Product Change Notification (PCN)

PCN Number: PCN_ConBHD_20260830 Affected Series: WR-BHD Affected Part Number: see table "PART NUMBER, REVISION & DATASHEET" PCN Date: 2026-07-30 (YYYY-MM-DD) Effective Date: 2026-08-30 (YYYY-MM-DD)	Change Category: ☐ Equipment/Location ☒ General Data ☐ Material ☐ Process ☐ Product Design ☐ Shipping/Packaging ☐ Supplier ☐ Software
Contact: Product Management Phone: +49 (0) 7942 - 945 5001 Fax: +49 (0) 7942 - 945 5179 E-Mail: pcn.eican@we-online.com	Datasheet Change: ☒ Yes ☐ No Attachment: ☐ Yes ☒ No

Because of a database mismatch, Würth Elektronik eiSos corrects values of withstanding voltage, two dimensions values, dimensions of carton and removes halogen free certification.

Drawing corrections:

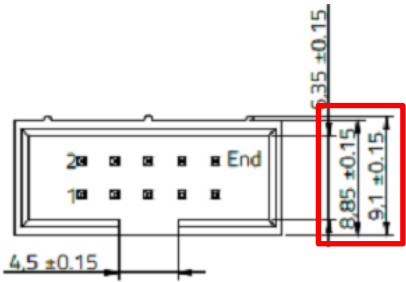
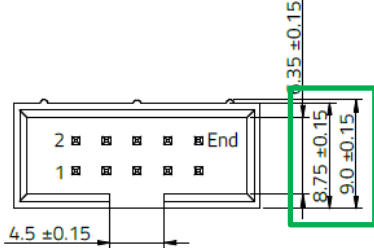
BEFORE CHANGE	AFTER CHANGE
